## 5 - Macrossan and Howard Streets, CBD – Comment on Trial LED Luminaires

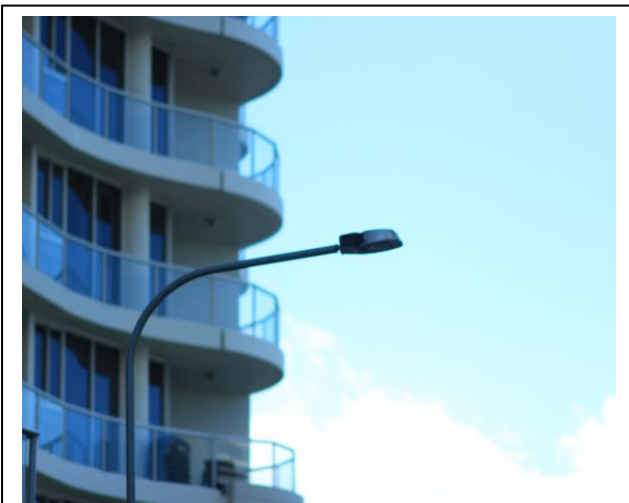
This is a harsh white light assumed to be 4000K. While such harsh lighting may have a role in public space lighting in the CBD, it is not suitable for residential streets.

The lighting appears very bright and more than what would be required for a residential street. However, even though pedestrians may consider these luminaires to be excessively bright they may be appropriate for public open-space lighting.

Even though this luminaire appears to have an Aeroscreen visor design it is very glary, particularly for pedestrians. There appears to be no shielding of the LED array in the 80° to 90° “glare zone”. Pedestrians may find they squint and avert their vision downwards when walking under these lights.

### Light Distribution

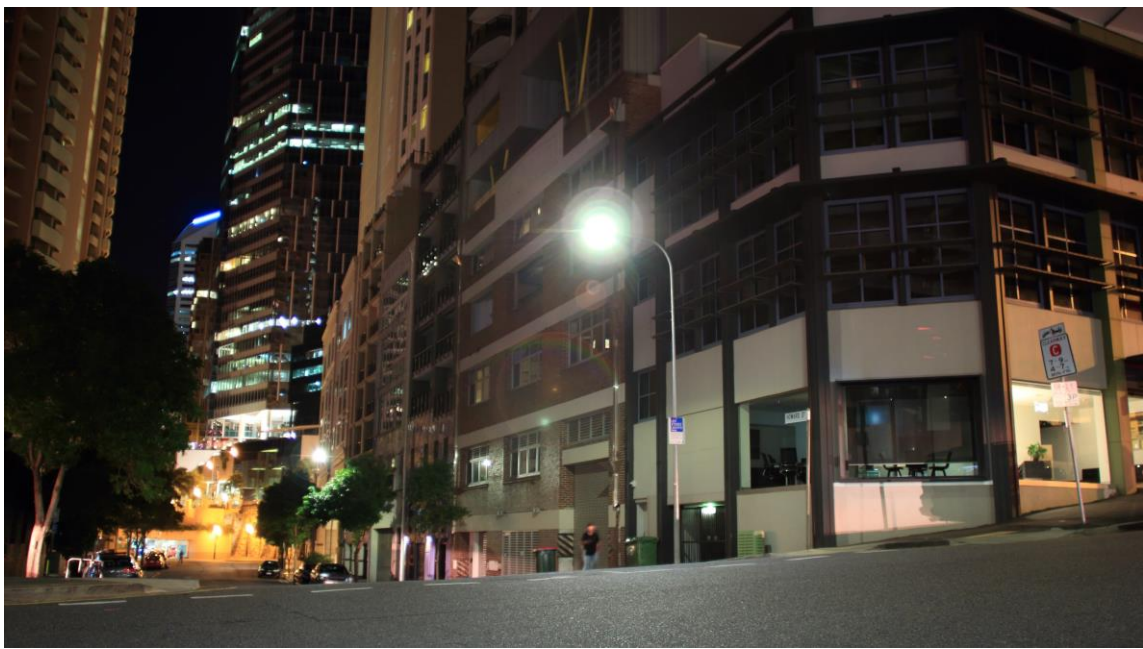
These luminaires deliver excessive backward light trespass on to private property.

Even though these luminaires are installed with about a 10° up-tilt they still delivery excessive light trespass to the rear on to private properties.

These luminaires are very bright and excessively glary for use in residential streets.
